Review Report

Review date; Time; Place: February 29, 2016; 9AM-5PM; CERN Bldg. 30.

Review process consisted of presentation from design engineers of various component of 7.5KA IGBT switch followed by closed door discussions among committee members.

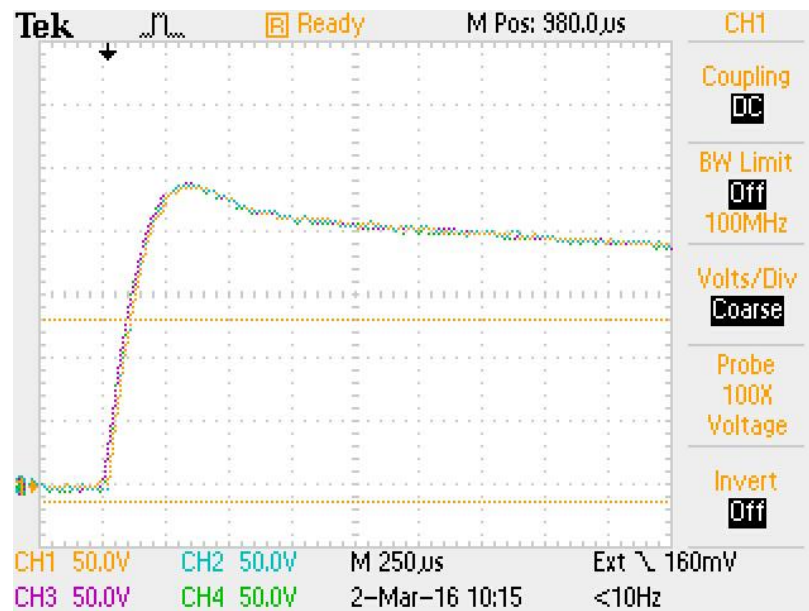
Test Results: Test results presented during the review and observed during real test provided enough proof of the sound and reliable overall design. Oscillographs of Vce and transient spikes at turn off are shown in Appendix B.

Vce Switch OFF transient captured at 2.5 μ S/div

Oscilloscope waveforms observed during the 7.5KA switch test

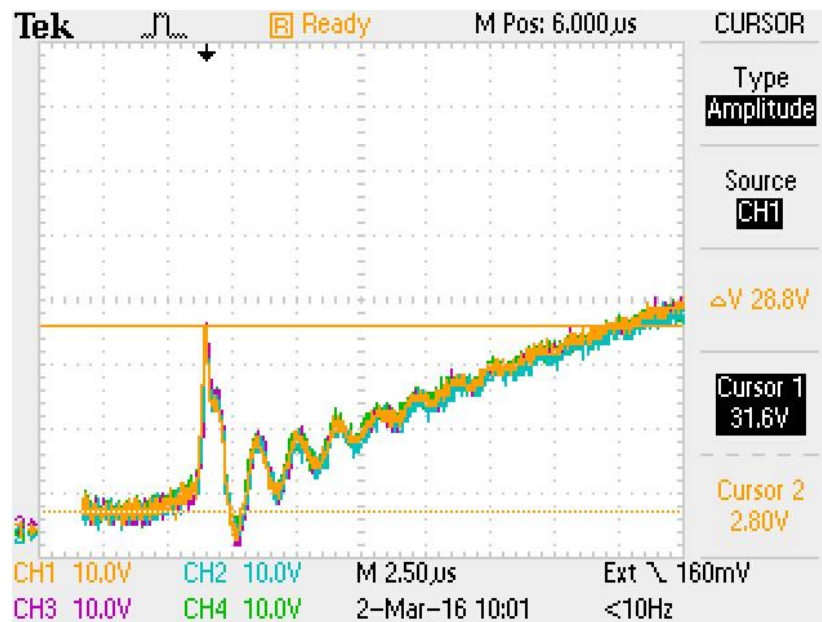
Vce at 250 μ S/div time scale. Peak reached is 460V
